# RENESAS TECHNICAL UPDATE

Product Category	MPU/MCU		Document No.	TN-RA*-A0008A/E	Rev.	1.00
Title	RA6T1, Errata for User's Manual: Hardware for SCE7		Information Category	Technical Notification		
Applicable Product	RA6T1 Group	Lot No.	Reference Document	RA6T1 Group User's Manual Hardware Rev.1.00		
		All

Figure 34.1 SCE7 block diagram

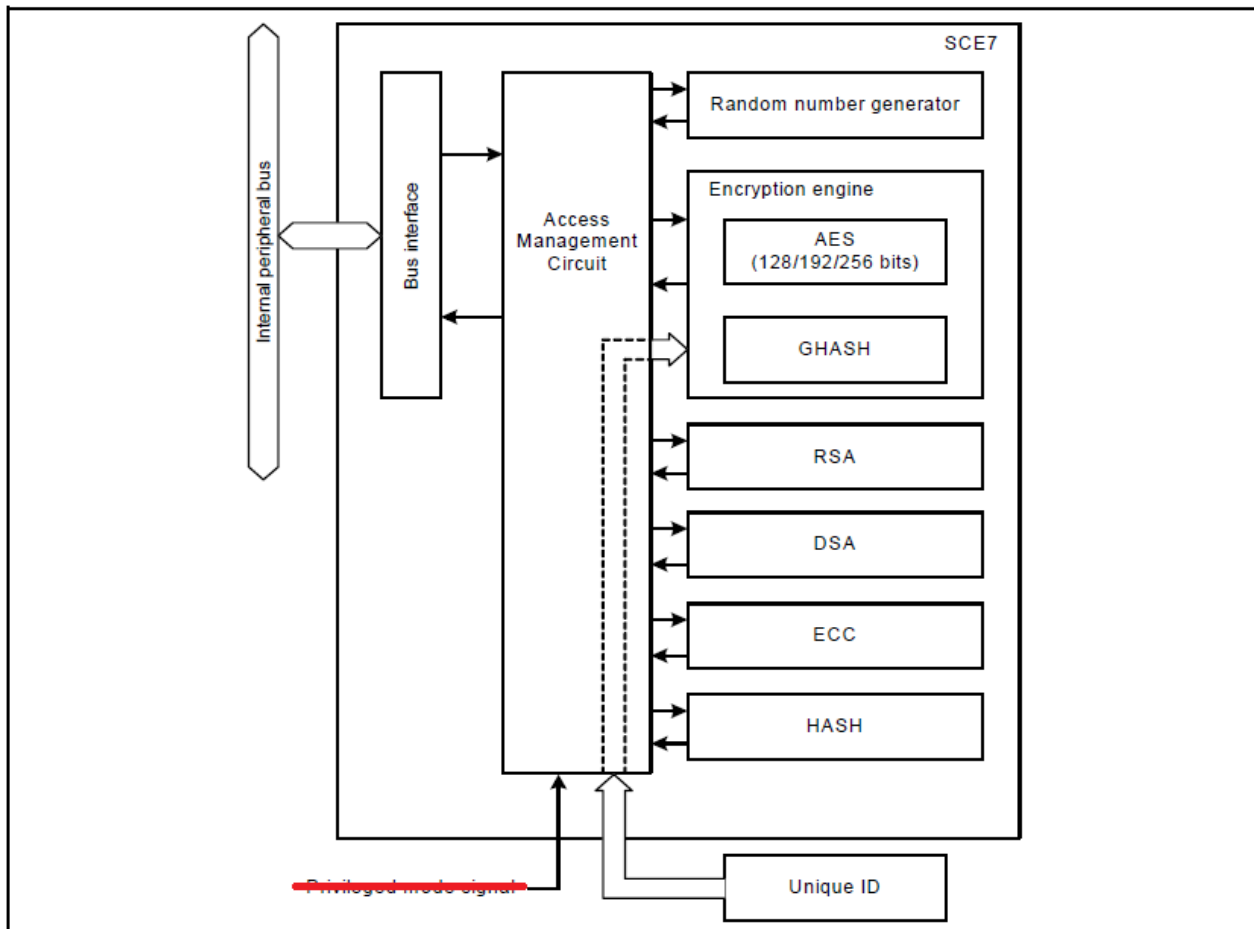
SCE7 is used in user mode and privileged mode. Therefore, the following descriptions should be deleted.

- In Figure 34.1, Privileged mode signal.
